Product Change Notification - SYST-19YAHF127

ERRATA - dsPIC33CK256MP508 Family Silicon Errata and Data Sheet Clarification

dsPIC33CK256MP508 Family Silicon Errata and Data Sheet Clarification

FIGURE 1-1: I/O RAMP

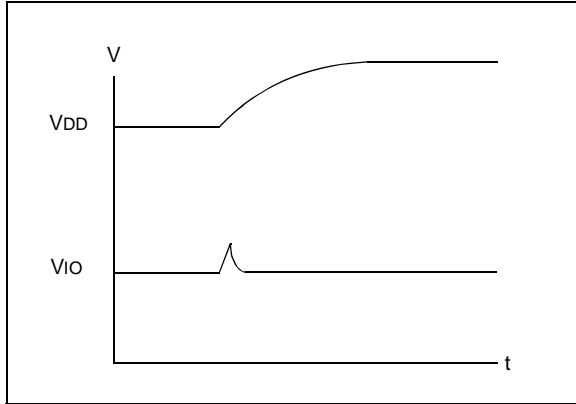
During a fast device power-up when the VDD ramp is less than 4 mS, the I/O pins may drive up to 100 μ A current for a duration of up to 10 μ S (Figure 1-1).

1. Slow down the VDD ramp time (greater than 4 mS for VDD to ramp 0V to 3.3V).
2. Ensure the circuitry that is connected to the pins can endure this pulse.

Example applications affected may include complementary power switches, where a transient current shoot-through might occur. High-voltage applications with complementary switches should power the high-voltage 200 μ Sec later than powering the dsPIC[®] device to avoid the current shoot-through. This behavior is specific to each device and not affected by aging.
